Bethesda Downtown Design Advisory Panel (DAP)

Project Name	7126 Wisconsin Avenue
File Number(s)	32019003A, 120230020, 820230020
Project Address	7126 and 7140 Wisconsin Avenue, 4705 Miller Avenue, 4708 Bethesda Avenue

site plan dap submission

illustrative - for conceptual purposes only
7126 wisconsin avenue | bethesda, md
dap submission | tower top

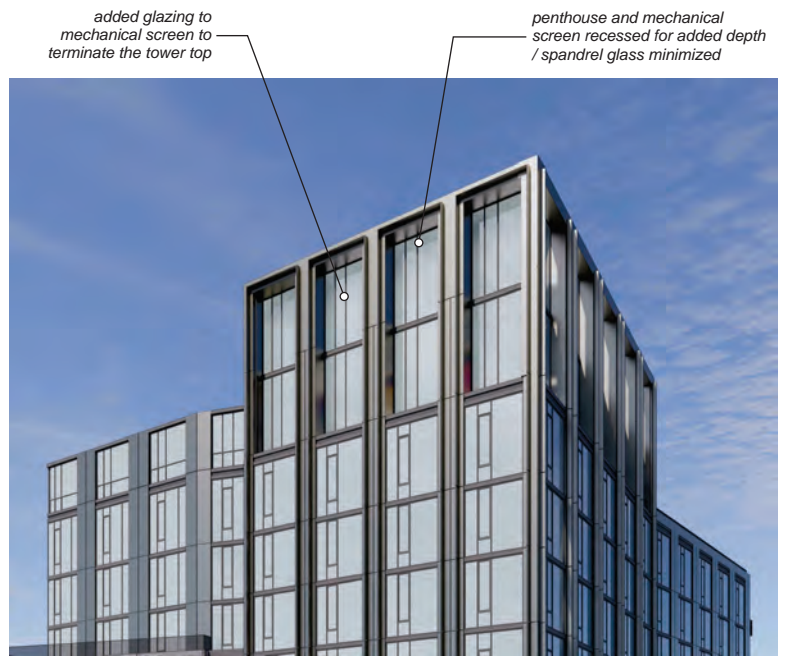
- the design of the column at the NE corner main entrance to be enhanced. This column is grounding the tower element providing an opportunity to create a "moment".
- the tower top should be embellished more. downplaying the spandrel glass between the windscreen and amenity would help.
- materiality and detailing to be more refined.

previous design from dap presentation 4.13.2022

revised tower top design
